# LONG WALL

# 253 LEAM ROAD

# DEVELOPMENT APPLICATION

REQUEST FOR FURTHER INFORMATION

**STORMWATER DETENTION PLAN**  
SCALE 1: 500

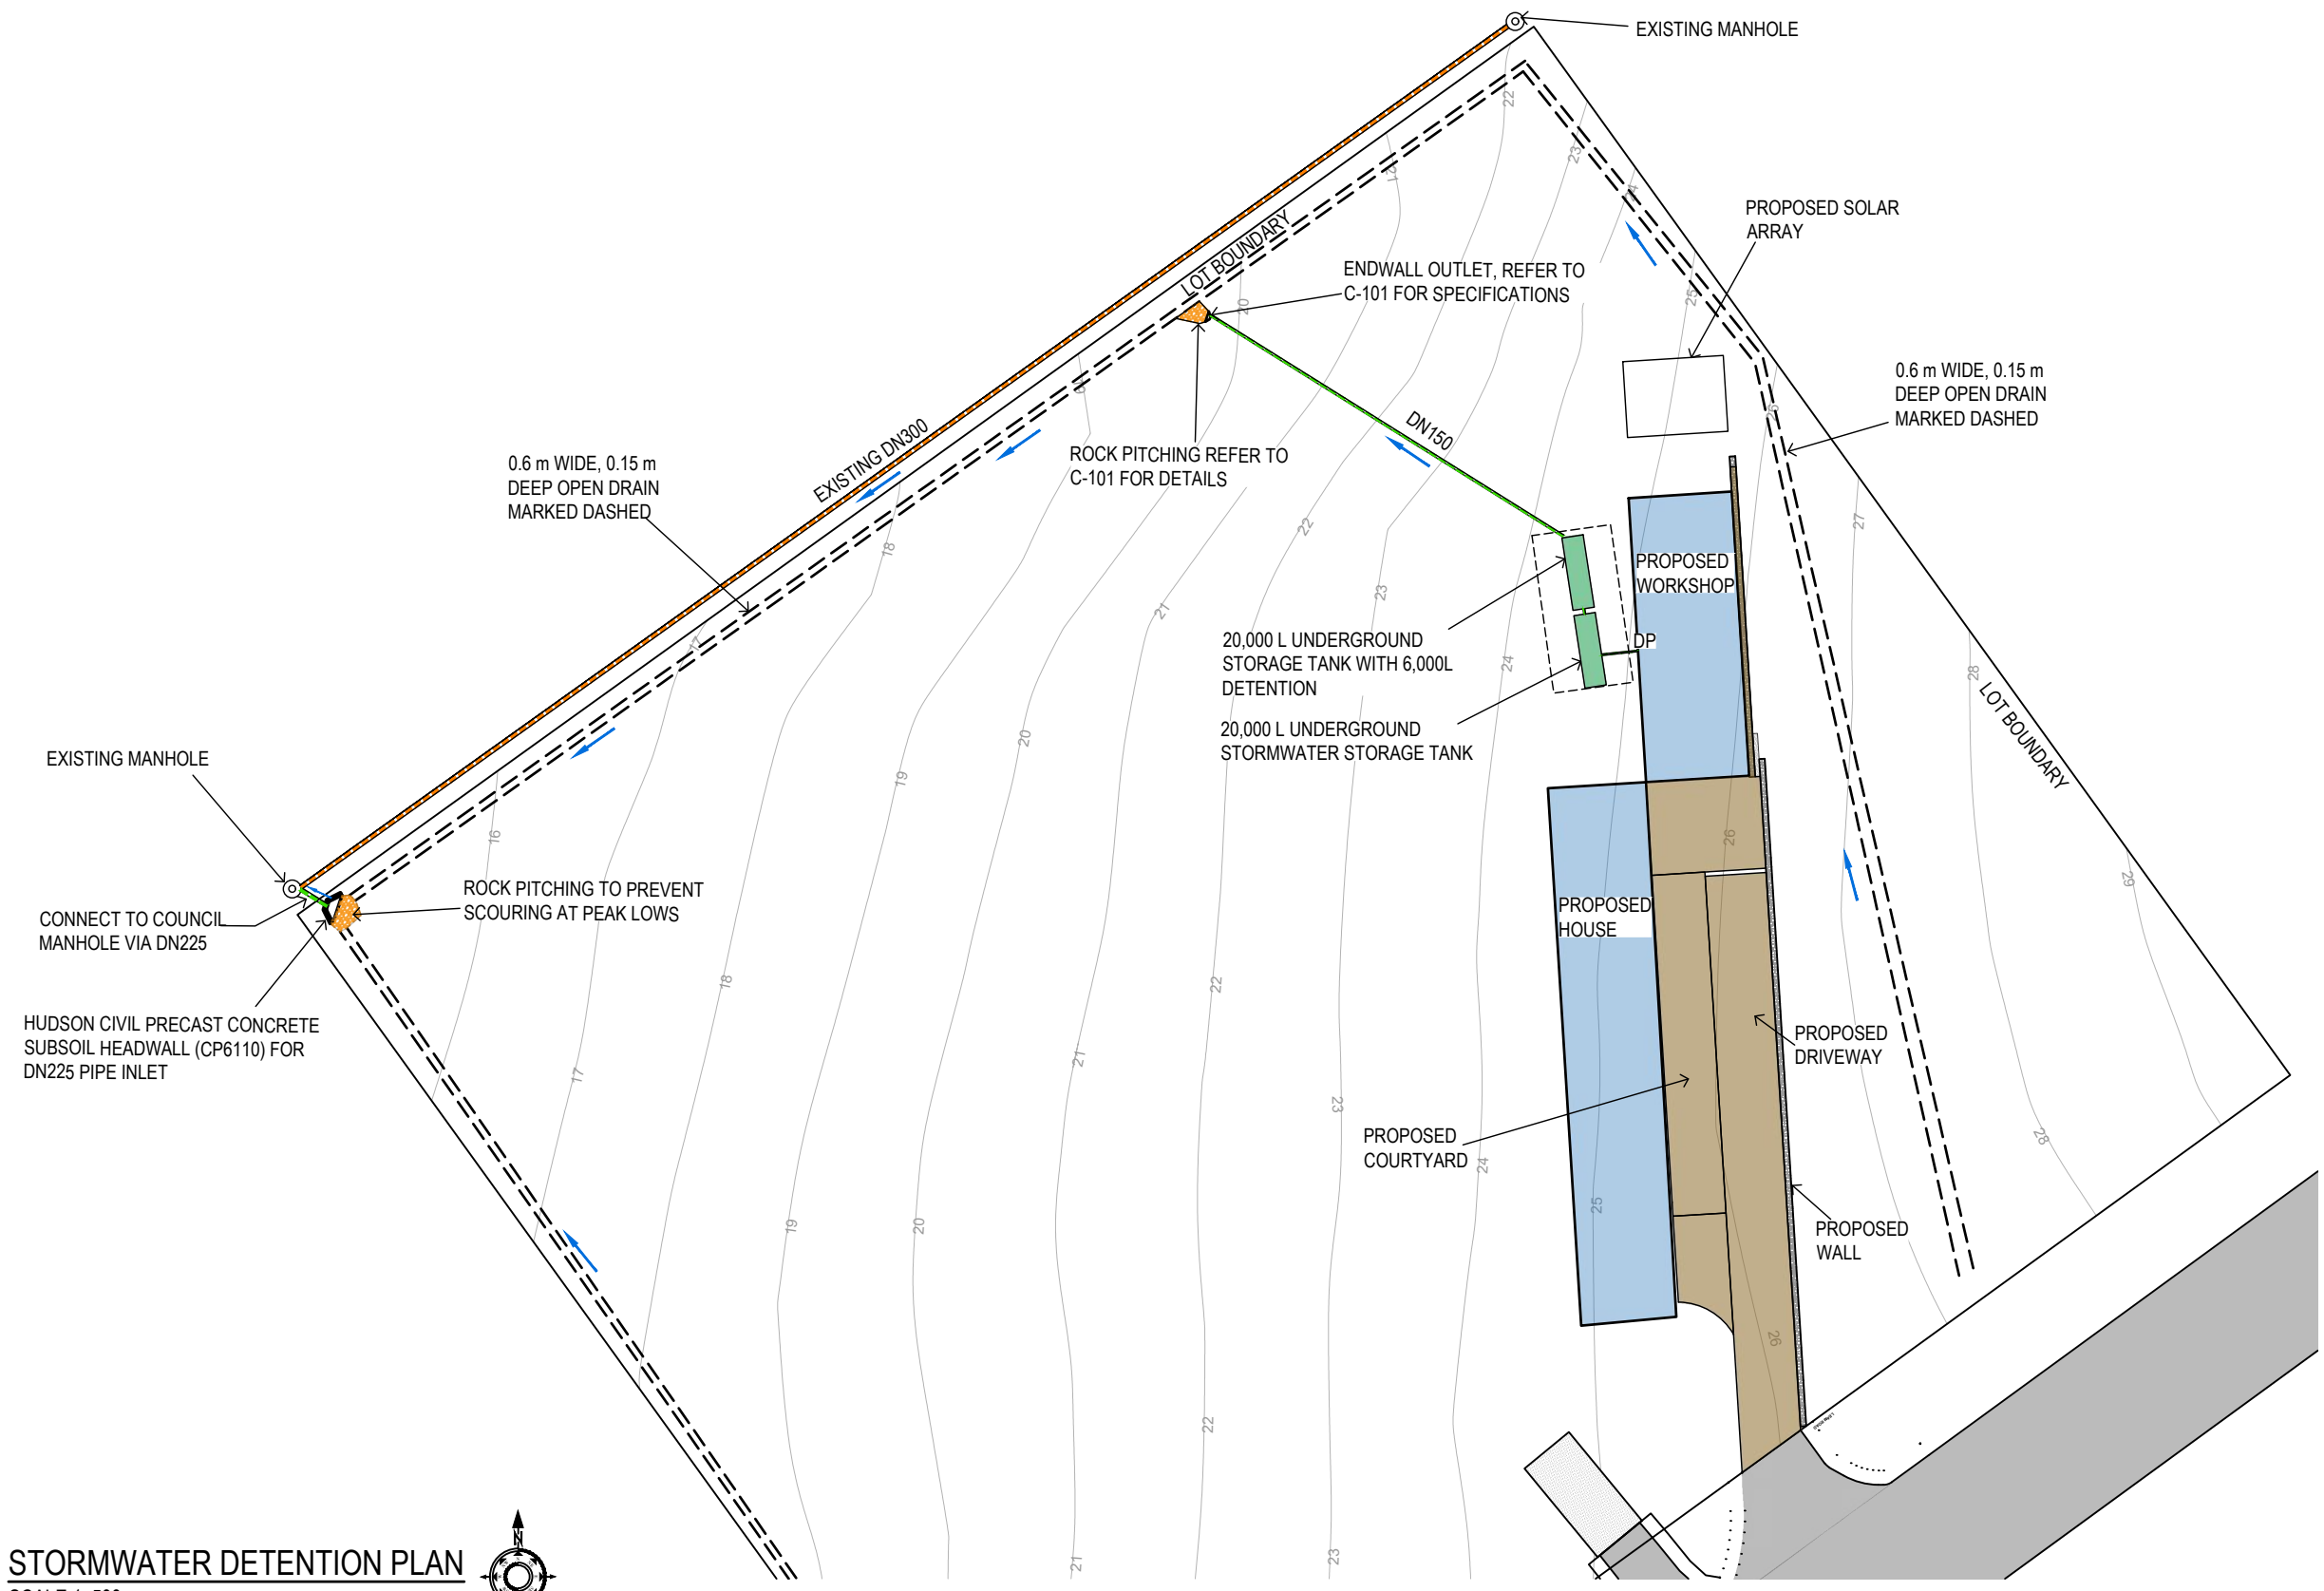
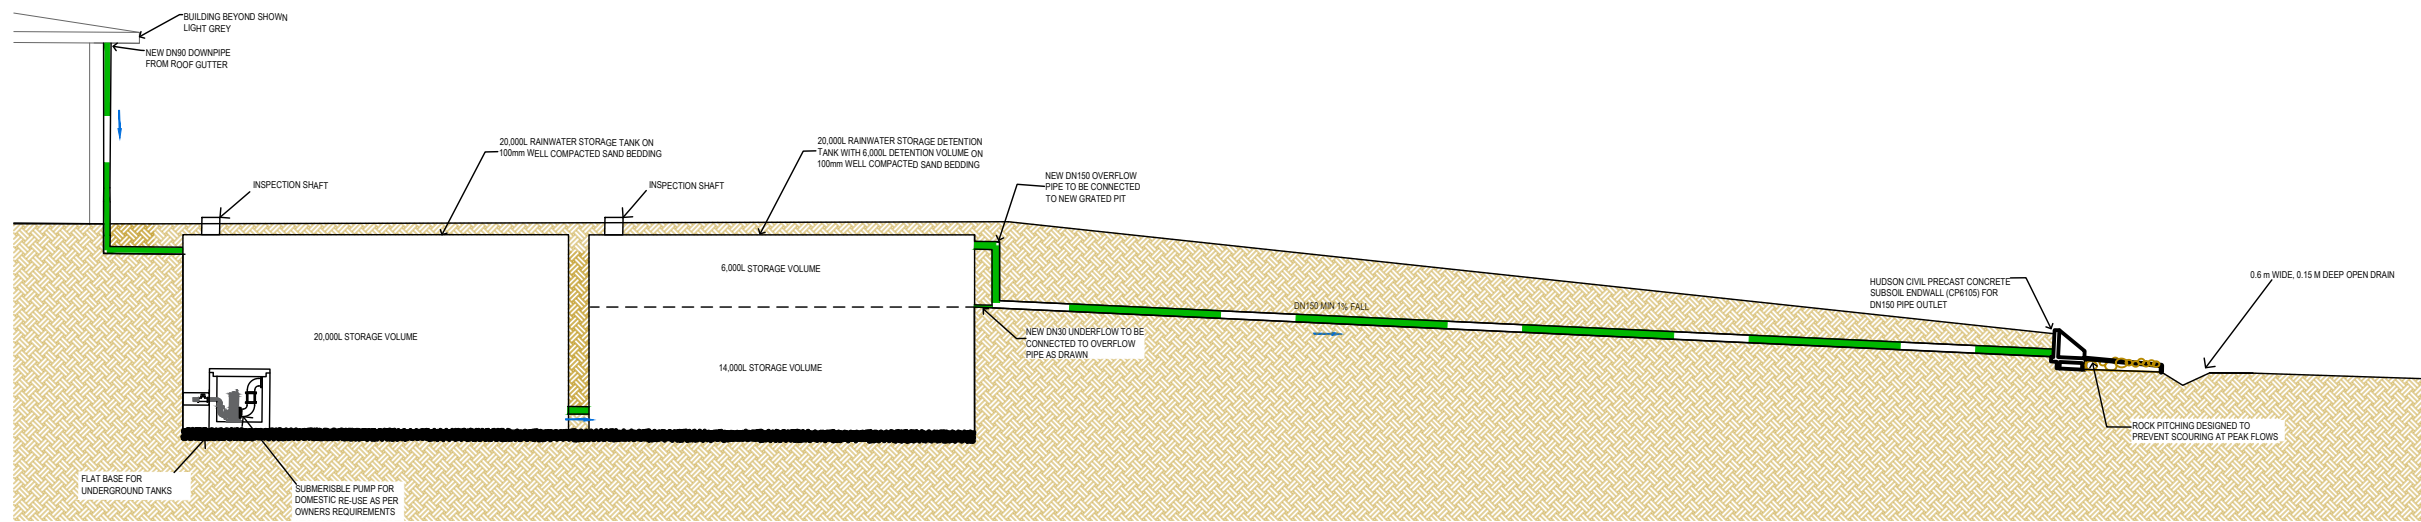
As can be read in the revised stormwater assessment/detention plan prepared by GES/Flussig Engineers, 0.6m wide & 0.15m deep open drains are to be added along the northern, western and along the rear side of the 'wall' to direct concentrated stormwater to the reticulated stormwater network. This statement directly addresses item #02 in the RFI 21.12.2023 & #4 of the request in the RFI 21.03.2024.

The suggestion is to add detention volume to the proposed rainwater tank and connect the outflow to the open drain along the lot boundary which then connects to the public stormwater system.
